NORTH LANTAU EXPRESSWAY

**Environmental Assessment Report
Tung Chung Section
Final Report
Agreement No. CE/18/81**

Government of Hong Kong
Highways Department

March 1992

Figure 4.19
1.5 Metre Trackside Barriers alongside the ARL and LAL

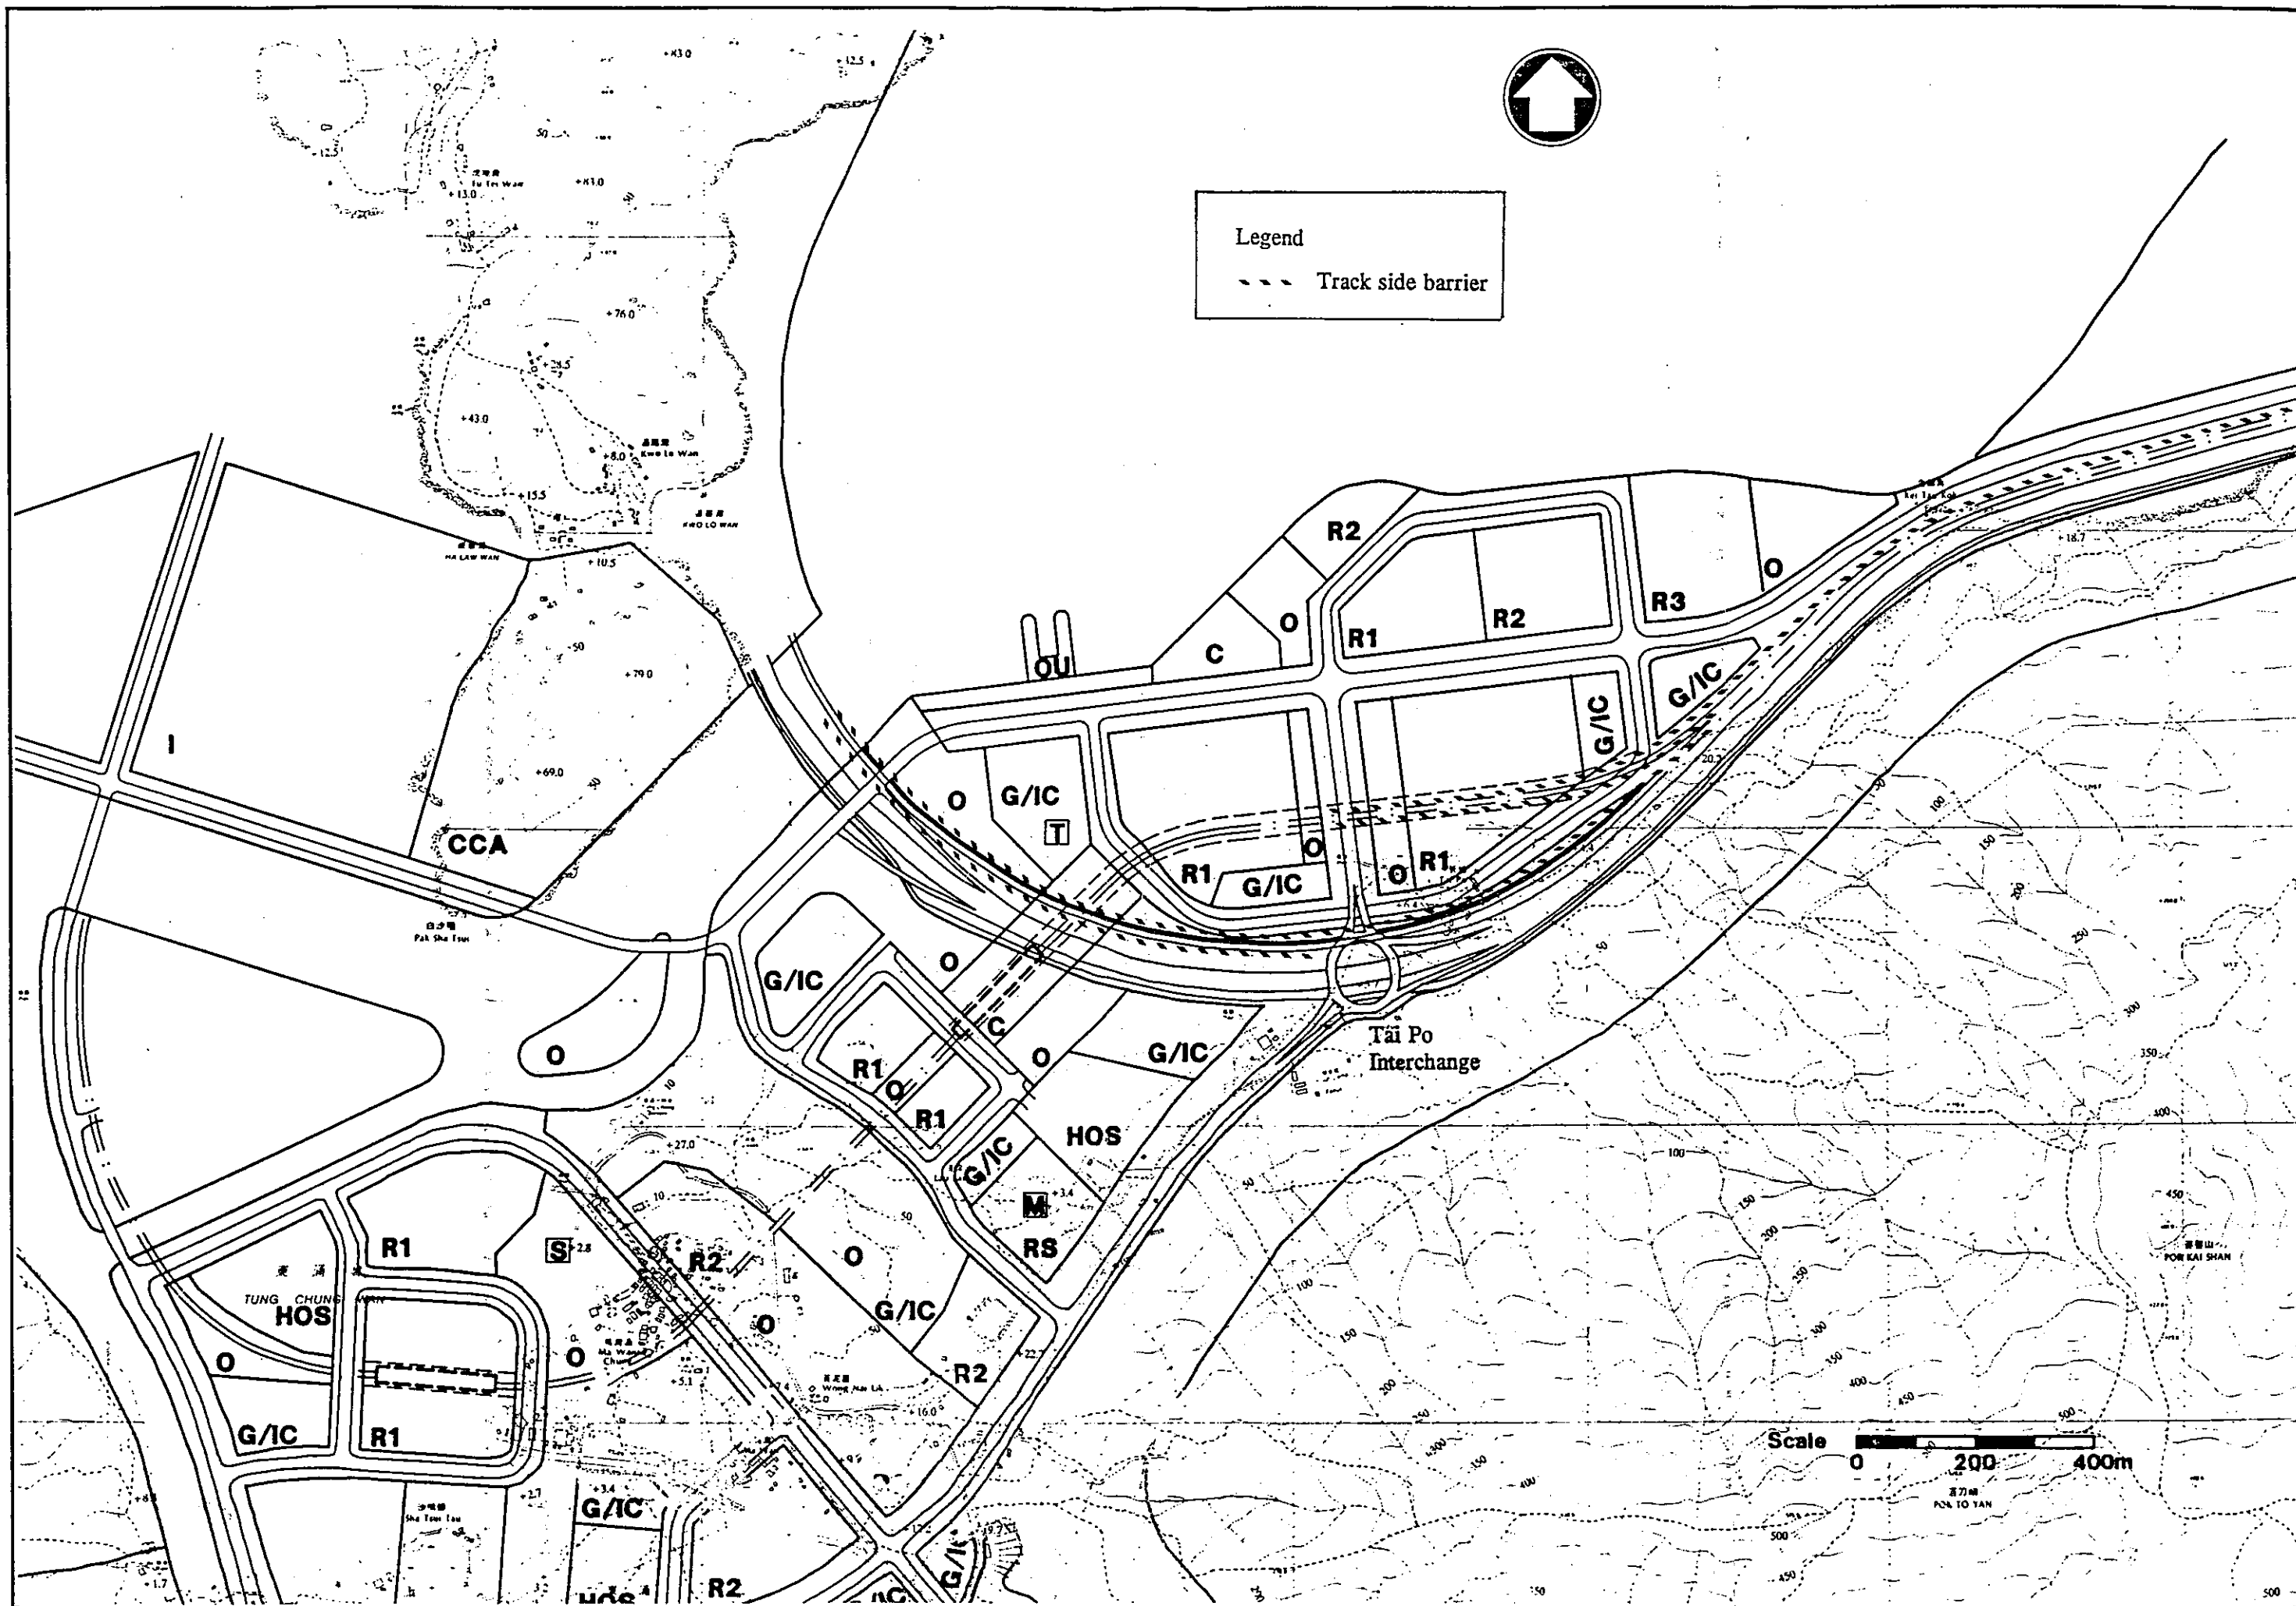
- (viii) Is it the case that the train noise is subsidiary to that of the road when the 1.5m high trackside barriers are installed? If so then the road noise contours shown on the plan prepared in response to (vi) will provide the critical noise factors to which the planning layout will require to respond. Nevertheless, a plan similar to Figs. 4.8 and 4.9 showing the rail noise contours with 1.5m high trackside barriers should be included in the report. As the elevated option LAL has not been ruled out, rail noise contour plans are required for both underground and elevated LAL options to be included in the report.

It is true that train noise will be subsidiary to that of the road when the 1.5m high trackside barriers are installed. In fact, noise contours with 1.5m barriers installed as in Fig. 4.19 have been prepared. However, the criteria lines become so close to the track with the given scale of drawing that no information can be extracted from such a drawing.
